**NSLPP MEETING HELD ON 02/08/2023****Attachments:**

ADDRESS/WARD: 63 Victoria Street, McMahons Point**APPLICATION No:** DA 357/22**PROPOSAL:** Alterations and additions to an existing semi-detached dwelling.**PLANS REF:**

OWNER: L Misener**APPLICANT:** A Machkevitch – Corona Projects Pty Ltd**AUTHOR:** Miguel Rivera, Senior Assessment Officer**DATE OF REPORT:** 18 July 2023**DATE LODGED:** 22 November 2022**RECOMMENDATION:** Refusal

Figure 7: Site/roof plan showing new roof terrace

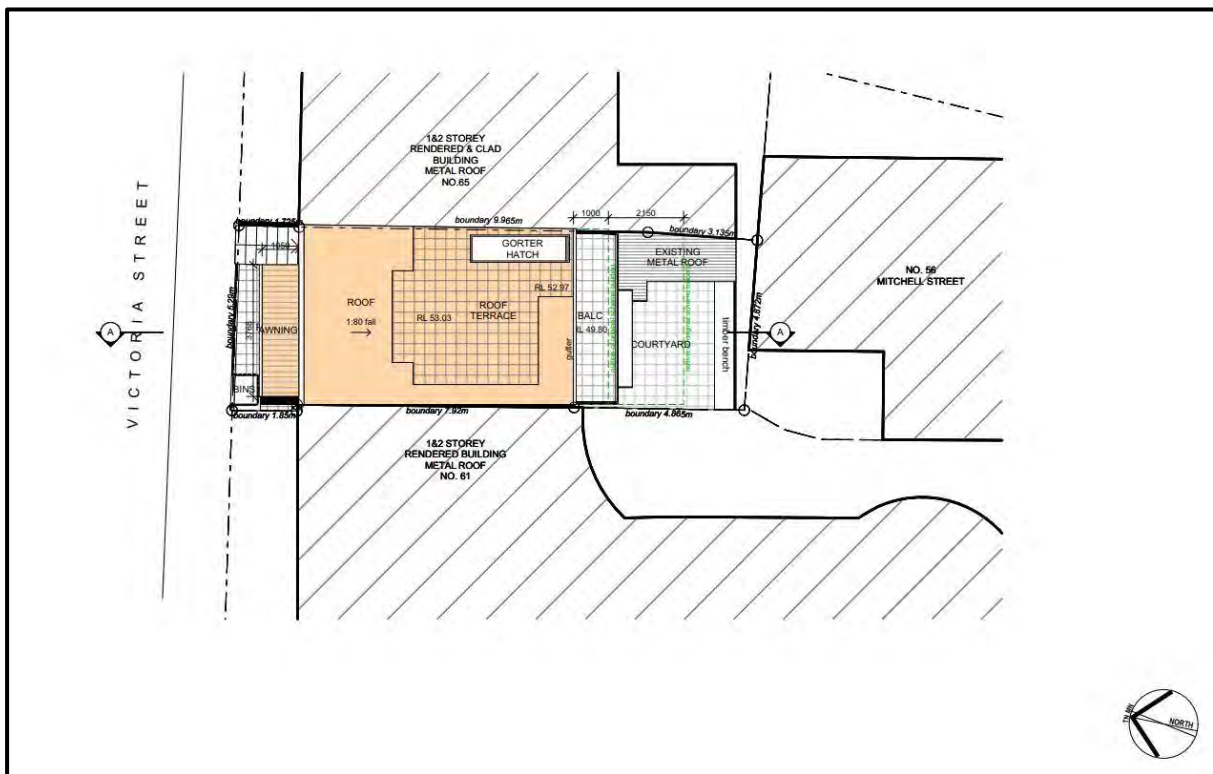
- The proposal fails to provide a compatible built form that is acceptable in terms of streetscape response, bulk, scale and appearance. The provision of a roof terrace is a key concern as it promotes a height breach that will result in view loss and amenity impacts.

Figure 37: Height diagram showing non-compliant components – roof terrace balustrades (shaded in pink) and roof terrace/first floor roof (shaded in orange) and the existing lower ground floor level and existing residential levels' differences compared to Victoria Street

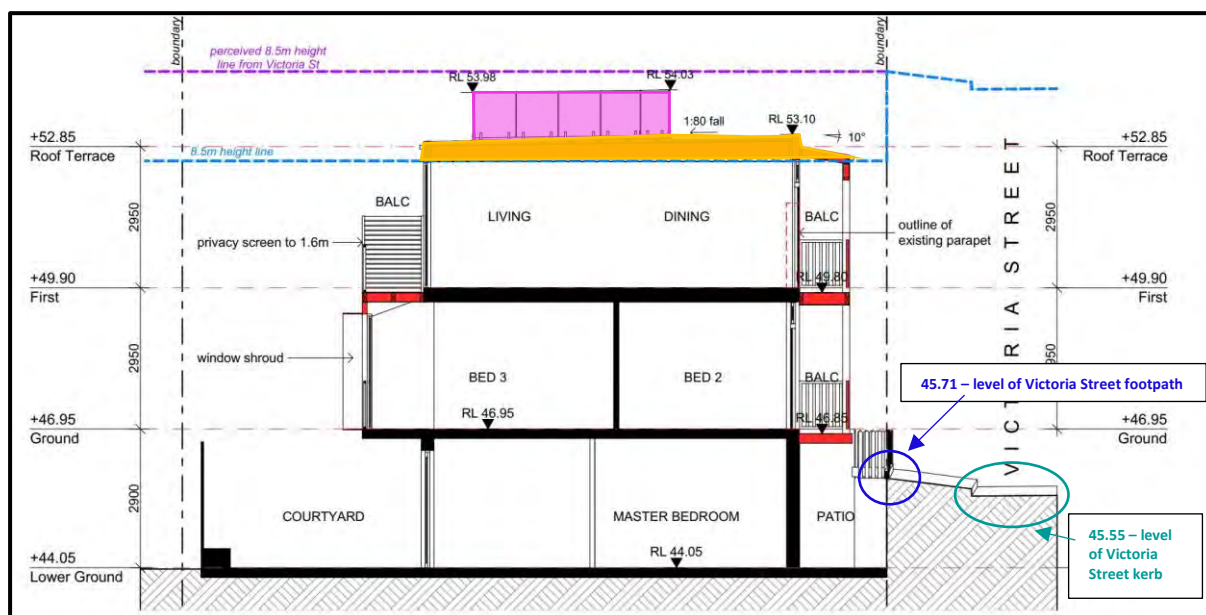
Figure 37 illustrates the non-compliant components of the proposed development.

The Applicant's written request has not demonstrated consistency with all objectives of the development standard and the relevant zone (E3). The Applicant's written request failed to demonstrate that compliance with the development standard is unreasonable or unnecessary and is unable to provide sufficient environmental planning grounds in support of the variation. Further, the application does not adequately substantiate the potential impacts of the non-compliance and therefore, support for the variation is not in the public interest. Given the above matters, the Applicant's written request fails to achieve the critical provisions under Clause 4.6 of the NSLEP 2013 and Council is unable to accept and support the non-compliance sought under this clause.

Figure 45: Standing view (zoomed in view) from the roof terrace of No. 62 Victoria Street – proposed built form shaded in green

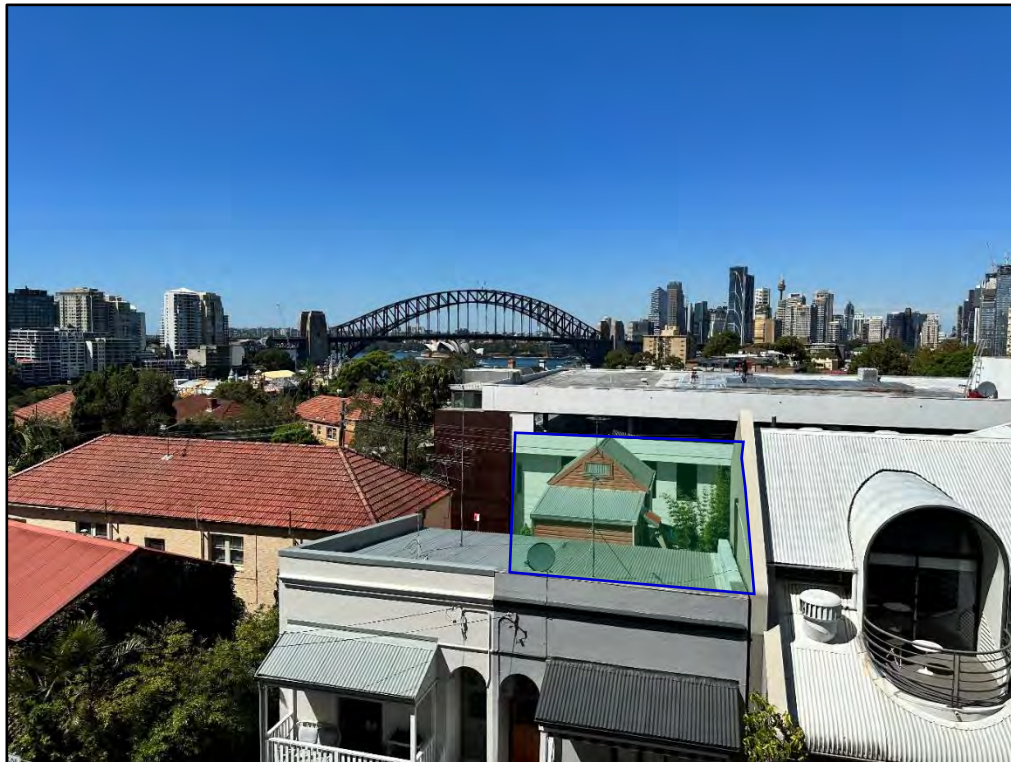
Assessment: The potential view loss impacts are considered acceptable and reasonable.

Figure 49: Option to provide vegetated screening centrally located, in front of the balcony

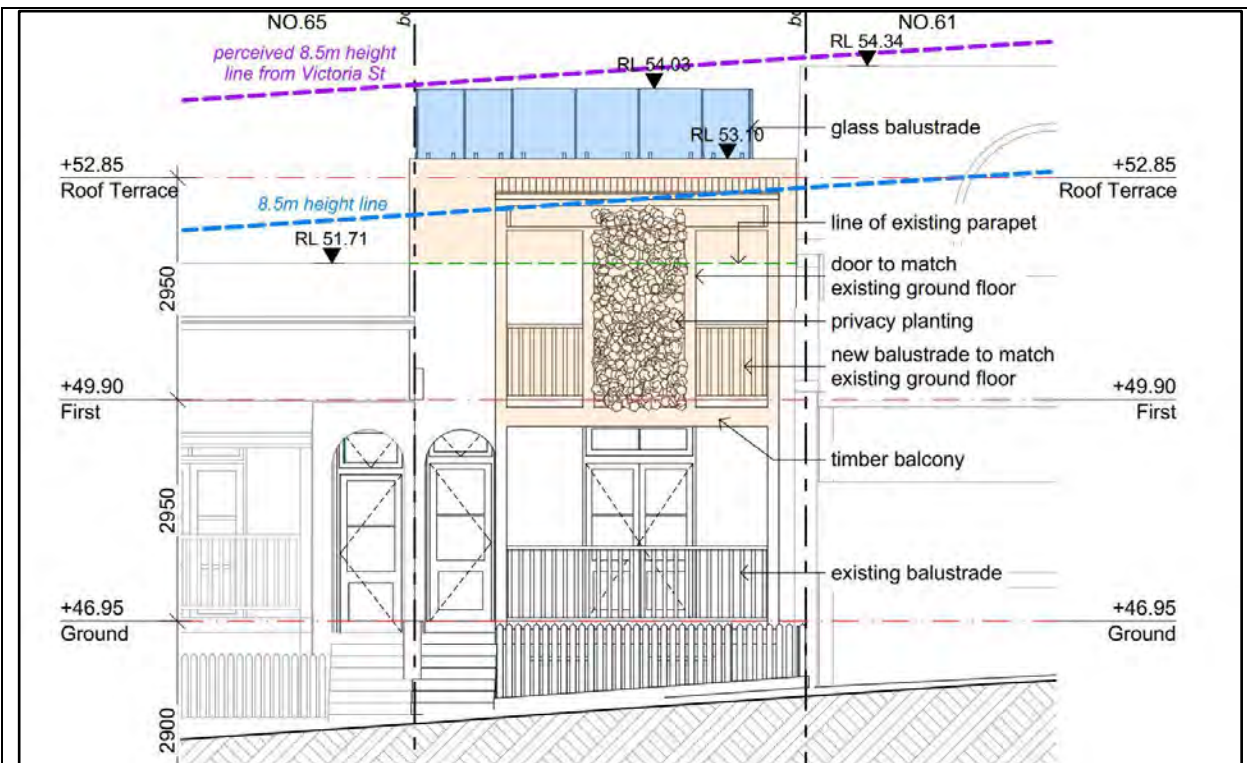
Acoustic privacy	No, demonstrates merit and consistency with the setting/context of the premises	The roof terrace and balcony (as amended) are considered acceptable in terms of acoustic privacy impacts – given the unique, urbanised and built-up context and setting of the site and surrounds and the occurrence of roof terraces/balconies/elevated living areas in the immediate locality.
Visual privacy	Yes	<i>Lower ground floor and rear courtyard</i> The proposed re-configuration of the lower ground floor will not result in substantial/adverse privacy impacts. This space will be converted to a bedroom with access to the current rear courtyard. This change is acceptable and any overlooking associated is reasonable.

Figure 50: Proposed roof terrace – 19.4m² (>18m²)

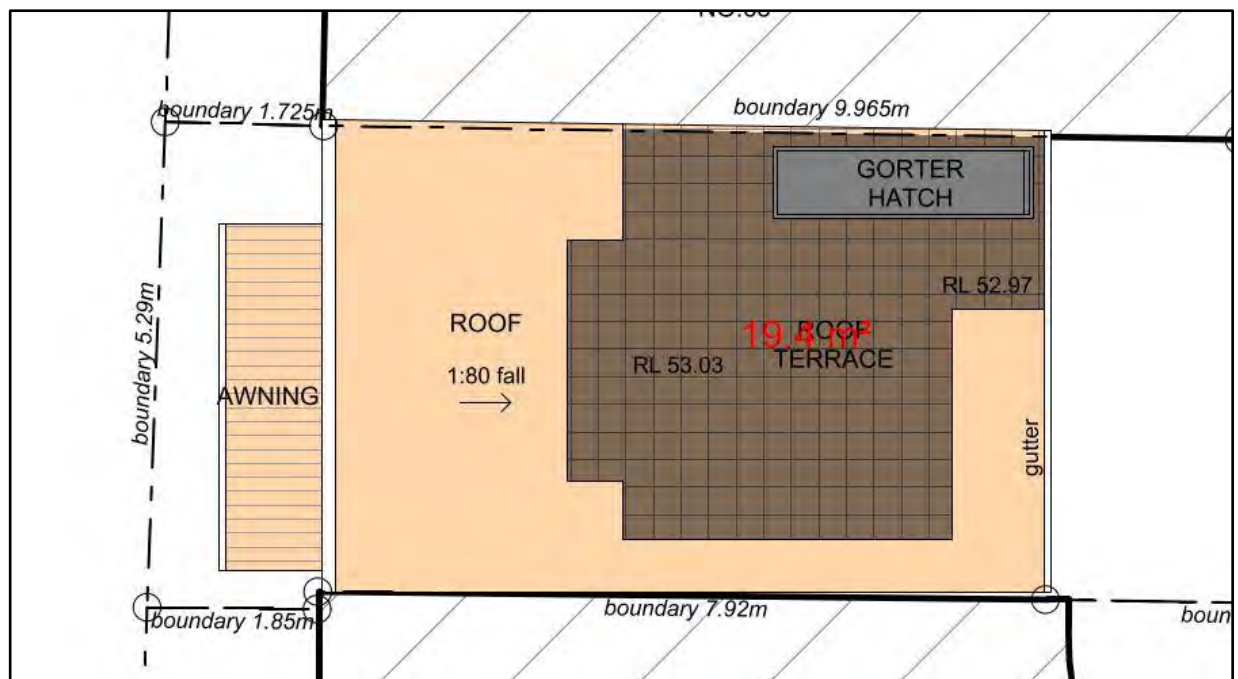
O2 To control the bulk and scale of buildings.	Yes	Setbacks are generally appropriate in controlling bulk and scale of proposed buildings/structures.
O3 To provide separation between buildings.	Yes	Appropriate separation is achieved.
O4 To preserve the amenity of existing dwellings and provide amenity to new dwellings in terms of shadowing, privacy, views, ventilation and solar access.	Yes	Acceptable – as demonstrated above.
Setback – side 1st storey (up to 4m): 0.9m (min.) 2nd storey (up to 7m): 1.5m (min.)	Yes	The proposed side setbacks vary from the numerical controls – however, are characteristic of the residential housing within the area.
Setbacks – rear	Yes	The first floor and its rear-facing balcony has been revised to be appropriately aligned with the established rear building line.
Form, massing and scale	No	The proposed form, density and scale of the proposed development are reflective of the existing dwelling and comparable to surrounding properties and will therefore, not detract from prevailing architecture and streetscape character of the vicinity. Note that the roof terrace should be removed to ensure built form is acceptable.

Figure 51: Party wall detail showing works over the property boundary (between No. 65 and 63 Victoria Street)

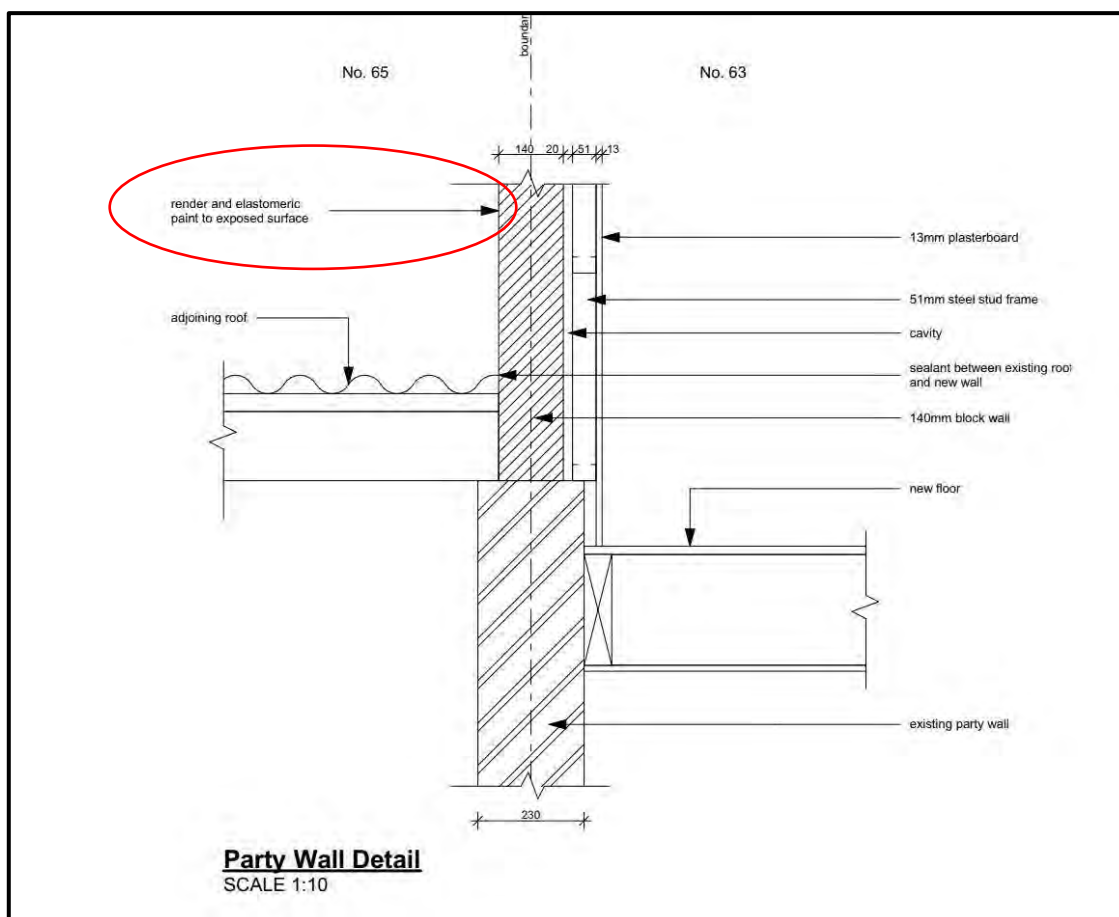
Response: This issue has been raised with the Applicant in the Withdraw/Refuse Letter (dated 16 March 2023). The original plans shows works over the property boundary including an extension of the centralised (property boundary) wall and intrusion into the common access stairs. The revised drawings has resolved some of these elements; however, some details appear to indicate that there will be new works over the property boundary (refer to Figure 51). Party wall consent was not obtained and provided to Council and this issue remains outstanding.

In order to address this issue, revised plans would need to be provided to Council to indicate that the proposal can be structurally supported and built without reliance on the party wall and impacts on the party wall. Council's Development Engineer provided conditions that can be imposed accordingly.

Figure 52: Error on floor plan

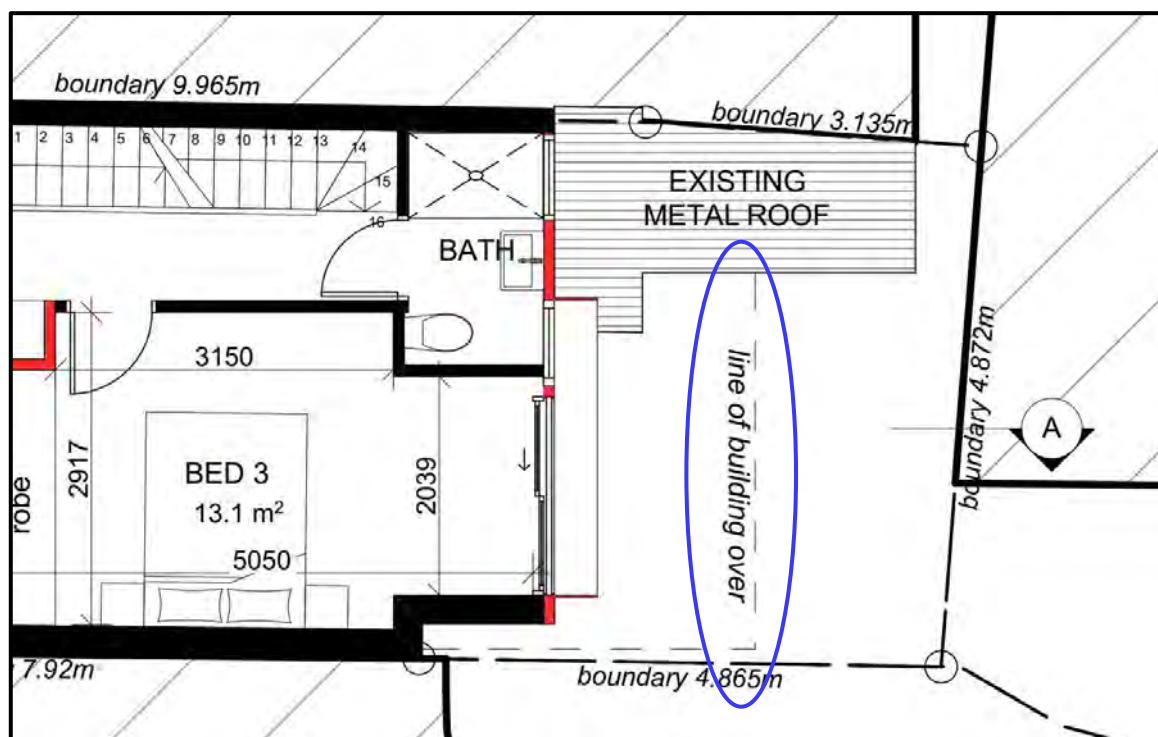
Council also noted the error in both sets, which showed an incorrect building line depicting extension of the top floor over (refer to Figure 52). This appears to be a drafting error. Re-submission of plans that eliminate this error was not necessary – Council is able to assess and determine the application with the recent set of plans.
